Recall Bulletin

SUBJECT: Brake Pedal Pivot Nut/Bolt Loose

MODELS: 2015 – 2016 Chevrolet Silverado HD
2015 – 2016 Chevrolet Tahoe PPV (RPO 9C1)
2015 – 2016 GMC Sierra HD

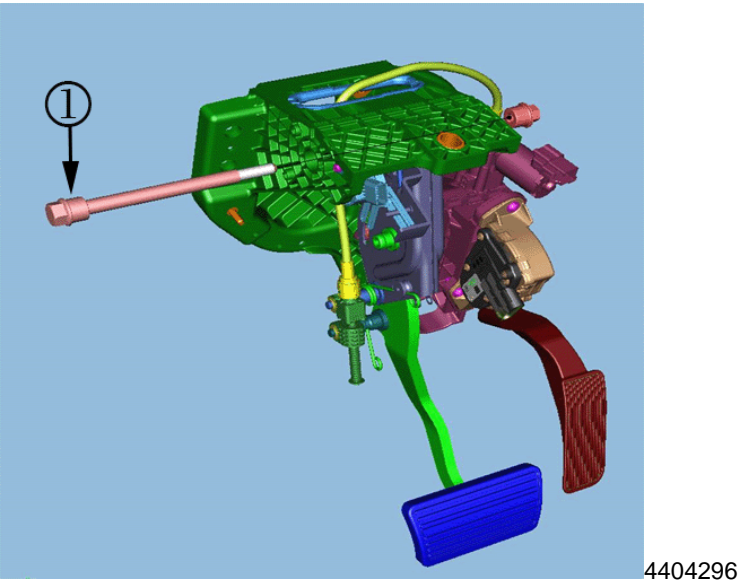
- Using an inspection mirror, determine if the brake pedal pivot nut is on the outboard side of the vehicle.

- If the brake pedal pivot nut (1) is on the outboard side of the vehicle, proceed to step 2.

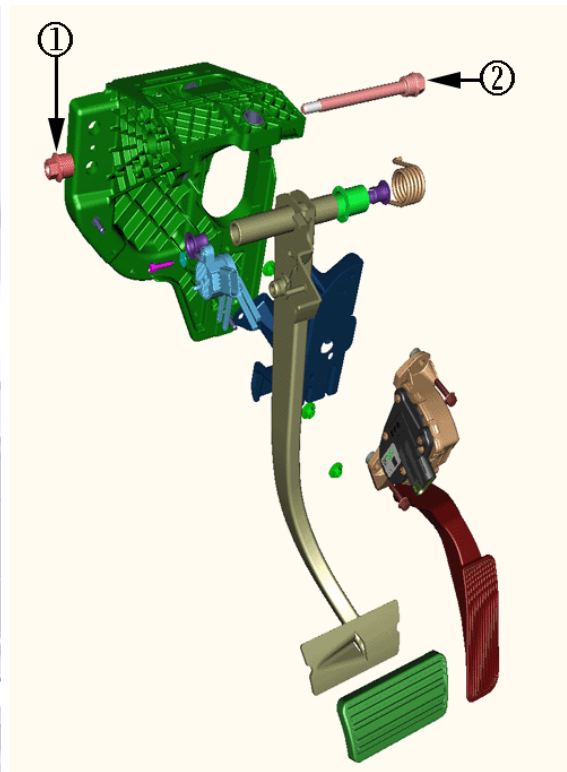
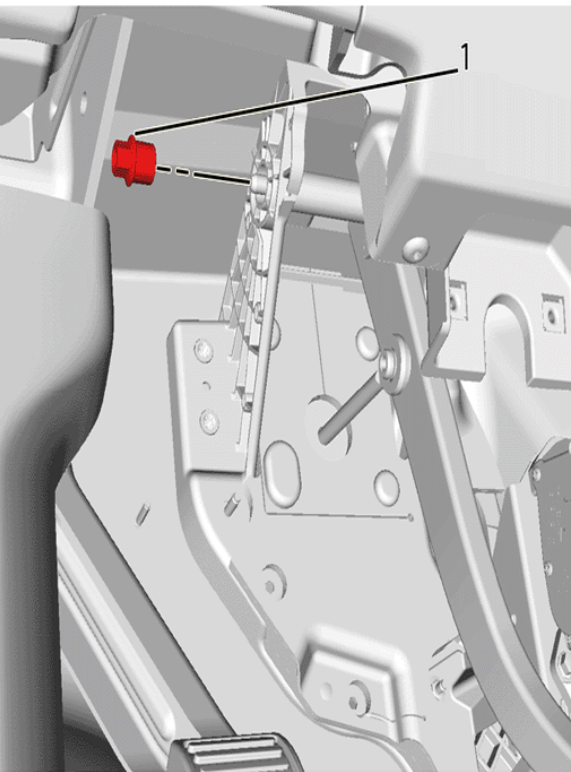
- If the brake pedal pivot bolt (1) is on the outboard side of the vehicle (nut on the inboard side), no further action is required.
2. Remove the Instrument Panel Knee Bolster. Refer to *Instrument Panel Knee Bolster Replacement* in SI.
 3. Remove the Floor Front Air Outlet Duct Replacement - Left Side. Refer to *Floor Front Air Outlet Duct Replacement - Left Side* in SI.

4404331

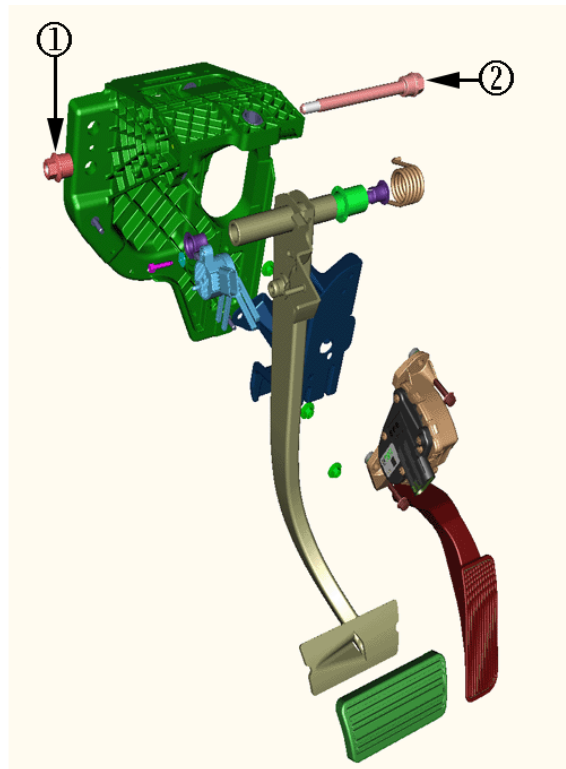
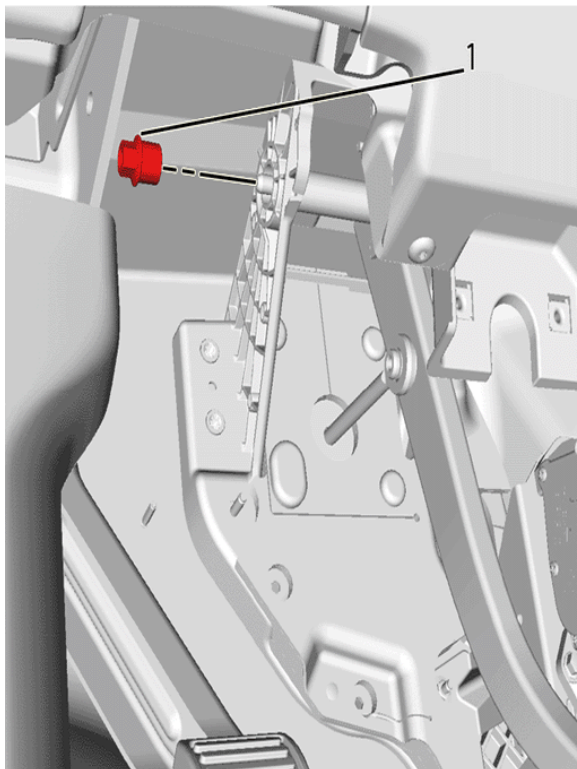
4. Holding the brake pedal pivot bolt (2) with a box end wrench, remove the brake pedal pivot nut (1).

5. Holding the nut horizontally, apply two drops of red threadlocker to the threads in the collar portion (1) of the nut.

6. Holding the brake pedal pivot bolt (2) with a box end wrench, install the brake pedal pivot nut (1).

7. Holding the brake pedal pivot bolt with a box end wrench, torque the brake pedal pivot nut to 26 Nm (19 lb ft).
8. Install the Floor Front Air Outlet Duct Replacement - Left Side. Refer to *Floor Front Air Outlet Duct Replacement - Left Side* in SI.
9. Install the Instrument Panel Knee Bolster. Refer to *Instrument Panel Knee Bolster Replacement* in SI.
